SCIENCE ADVISORY BOARD

EPA-SAB-24-007

Subject: Transmittal of the Final Science Advisory Board Report: *Review of the Science Supporting the Proposed Rule Titled, New Source Performance Standards for Greenhouse Gas Emissions from New, Modified, and Reconstructed Fossil Fuel-Fired Electric Generating Units; Emission Guidelines for Greenhouse Gas Emissions from Existing Fossil Fuel-Fired Electric Generating Units; and Repeal of the Affordable Clean Energy Rule (RIN 2060–AV09)*

Figure 2. Data Inputs and Outputs for the BenMAP-CE Model.

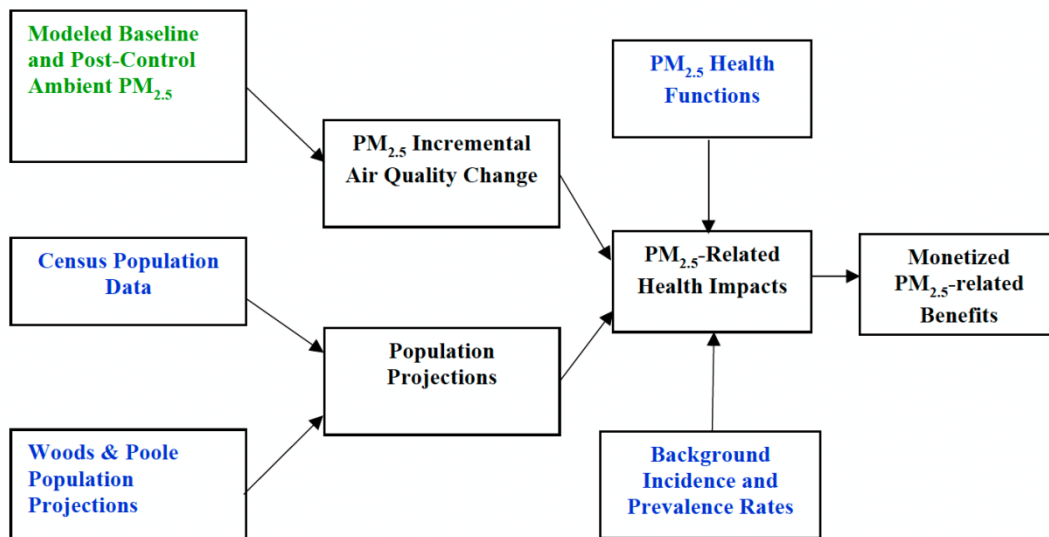
A more comprehensive description of the overall framework for estimation of the health benefits would be helpful to the reader. The descriptions are somewhat disconnected across the RIA and the Executive Summary should be revised to do a better job of describing how the various components and data sets are utilized and integrated. The handling of uncertainty should be bolstered to more fully explore the assumptions and attendant uncertainties covered on pages 4-38 and 4-39 of the RIA. An expanded discussion should address how the uncertainties covered by the assumptions made could affect the magnitude and direction of the estimates of health benefits.

Figure 2 outlines the framework for estimating the monetary benefits of reducing the adverse effect of PM_{2.5} and ozone. Changes in pollutant concentrations under the three scenarios are estimated with CAMx and combined with a risk function, derived from epidemiological investigations, to calculate the changes in attributable numbers of events using BENMAP-CE. The cost estimates are based on use of willingness to pay figures derived from the literature.

This approach to defining and describing sources of uncertainty and their consequences provides an incomplete presentation of the actual ranges of values associated with the estimates of morbidity and mortality events and the cost benefits. The confidence intervals inherently understate the true range of values consistent with the uncertainties in the input data. Errors in the exposure estimates are not propagated into the calculation of health and cost benefits. The tables should provide an appropriate caveat concerning interpretation of the 95% confidence intervals, acknowledging that they capture only one contributor to uncertainty—stochastic variation.
